56. Introduction to Ethernet for subscriber access networks

56.1 Overview

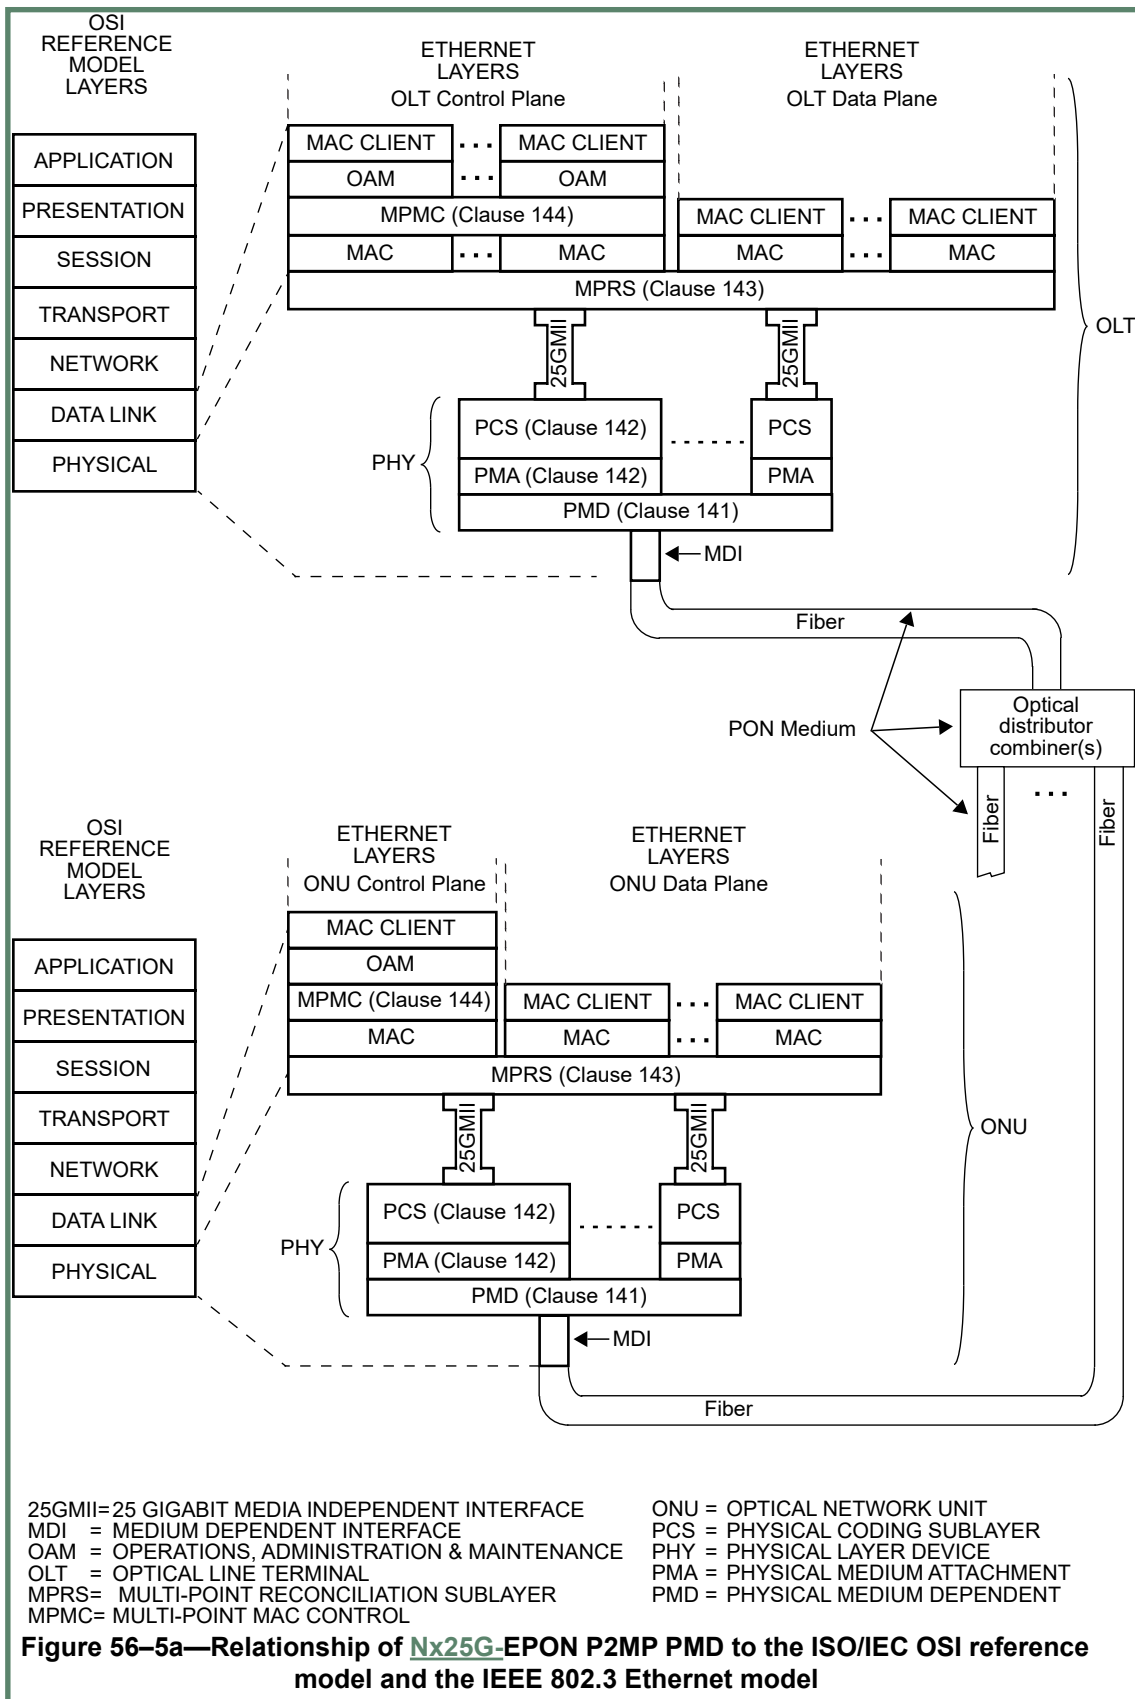
Modify a new Figure 56-5a after existing Figure 56-5:
